# Access Compliance Report

## Public Rights-of-Way

### (Curb Ramps)

Intersection ID: 12388	Main Street: BERRYHILL_RD	Cross Street: GREENLAND_AV	Location: NE
ADA ID: 5E006A02A75A	Ramp Type: Combination1Diag	Initial Pass/Fail: Fail	Overall Compliance: No
		Severity Score: 0

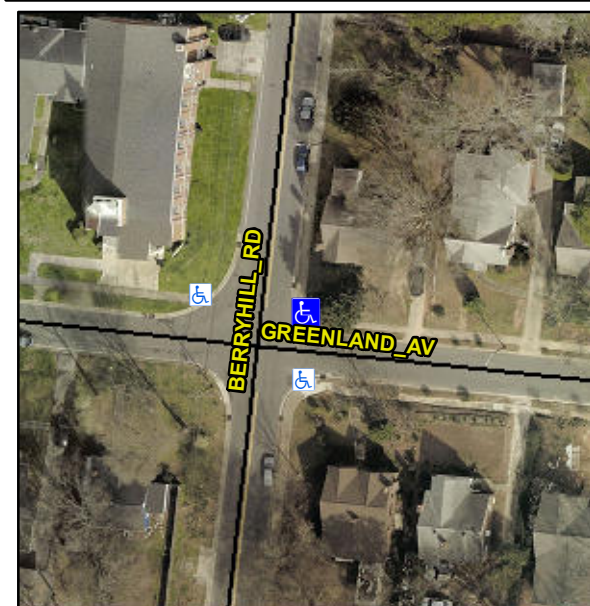
**RP & LT RP < 5%**

**Not Found, R304.5.1, R304.5.1, R304.5.3**

**Remove & Replace Curb Ramp With Two New Directional Ramps or Equivalent.**
